SUBJECT: STABILIZER TRIM STOP/SCREW MODIFICATION

MODEL/S/N AFFECTED: M20J - S/N 24-0001 THRU 24-1694 & 24-3000 THRU 24-3172
 M20K - S/N 25-0001 THRU 25-1230
 M20L - S/N 26-0001 THRU 26-0041
 M20M - S/N 27-0001 THRU 27-0058

FIGURE SI M20-88-1

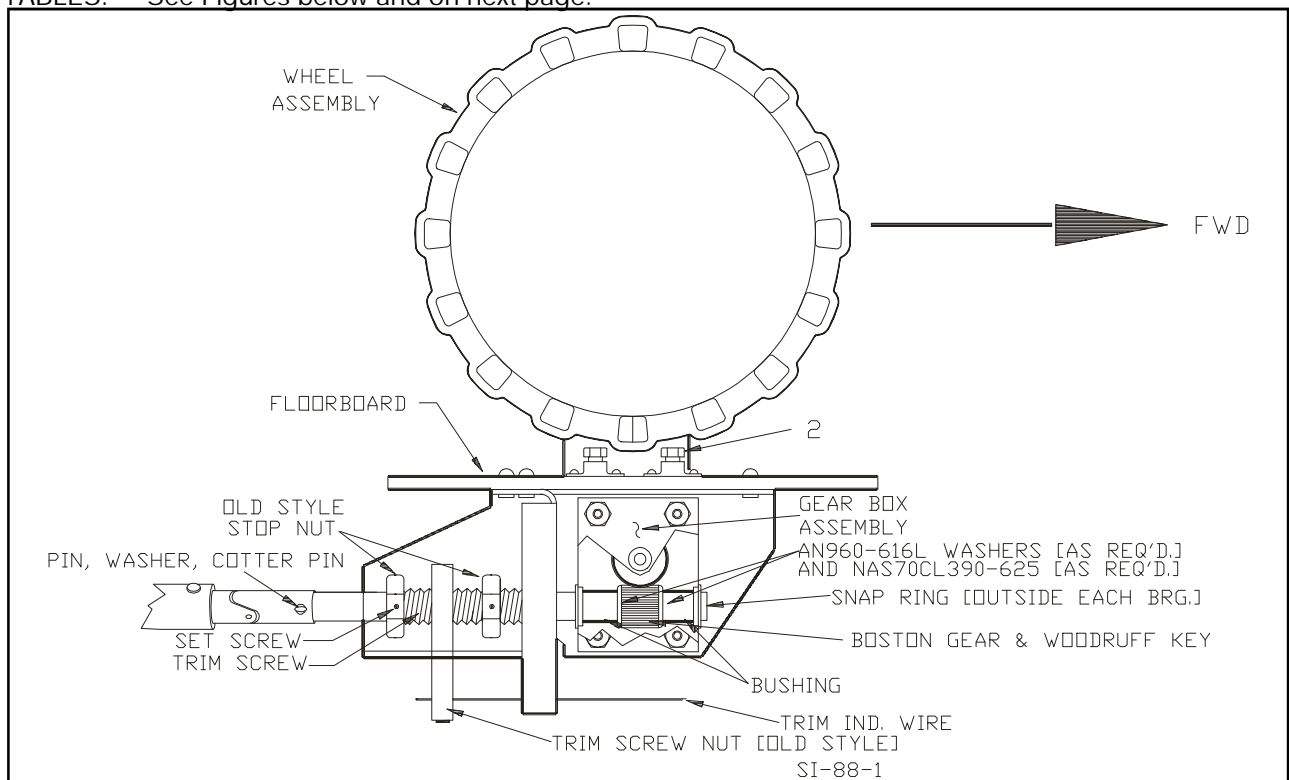
4. Remove cotter pin, washer and pin that secures trim tube universal joint to trim screw (Figure SI M20-88-1).
5. Loosen gear box bolts (Index 1, Figure SI M20-88-2) if not already done, and both NAS428-3-4 bolts (Index 2, Figure SI M20-88-2) to give slack in roller chain between upper and lower sprocket of trim control wheel assembly.

7. Remove roll pin, P/N RPA52-028-125-1125 holding lower sprocket, P/N 740049, to gear box shaft. Remove sprocket.
8. Loosen set screw, #6-32 x 1/8, in each existing trim stop so they will unscrew easily. Remove aft trim stop (DN stop) from trim screw (Fig. SI M20-88-1).

12. Measure and document lateral free play in trim screw shaft (length wise play) as assembled in the gear box assembly.
13. Remove forward snap ring from trim screw. Reference Figure SI M20-88-1
14. Lightly tap trim screw at forward end, with a plastic mallet, to drive trim screw, bushings, washers, gear and aft bearing from gear box assembly housing. Bearings are installed with locktite (Blue) at assembly, so some effort may be required to break it loose. **DO NOT DAMAGE BEARING NOR HEAT THE HOUSING.**
15. When existing trim screw, and components attached to it, comes free from gear box housing, the bushings, washers, gears, woodruff key, snap ring and aft bearing will be removed. Retain components, except woodruff key, to place back on new trim screw (Fig. SI M20-88-1).

FIGURE SI M20-88-2

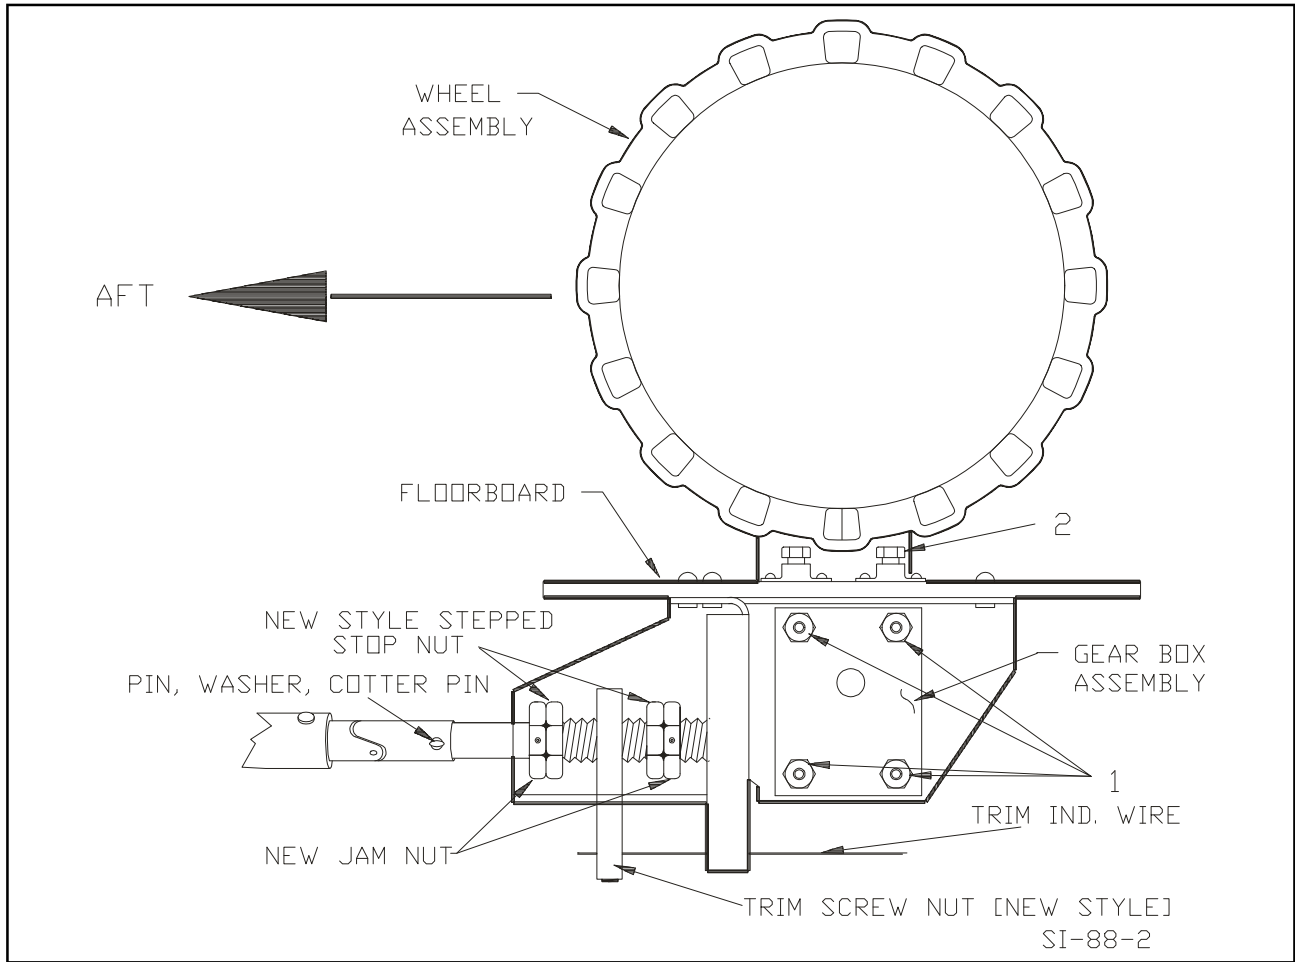
1. Remove belly access panels or smooth belly fairing to gain access to lower side of the trim control wheel assembly.
2. Remove trim indicator wire from trim screw nut by loosening set screw(s) that restrain trim wire.
3. Remove any brackets connected to gear box bolts (Index 1, Figure SI M20-88-2) both sides if required. Different models have different type of brackets.

22. Install one jam nut (UP stop side), P/N 740086-003 (M20J) or 740086-001 (M20K, M20L or M20M), on trim screw. Screw toward gear box housing leaving approximately 0.375 inch gap on threads between gear box and jam nut (Figure SI M20-88-2).
23. Install one stepped stop nut (UP stop), P/N 740086-007 (M20J) or 740086-005 (M20K, M20L or M20M) on trim screw. Screw toward gear box housing and against jam nut installed in step 22.

27. Reverse Steps 2 thru 7 to reposition gear box assembly back on trim wheel assembly. Do not tighten trim indicator wire set screw at this time. Position all other brackets but do not tighten bolts holding gear box assembly to trim wheel assembly (Fig. SI M20-88-2).
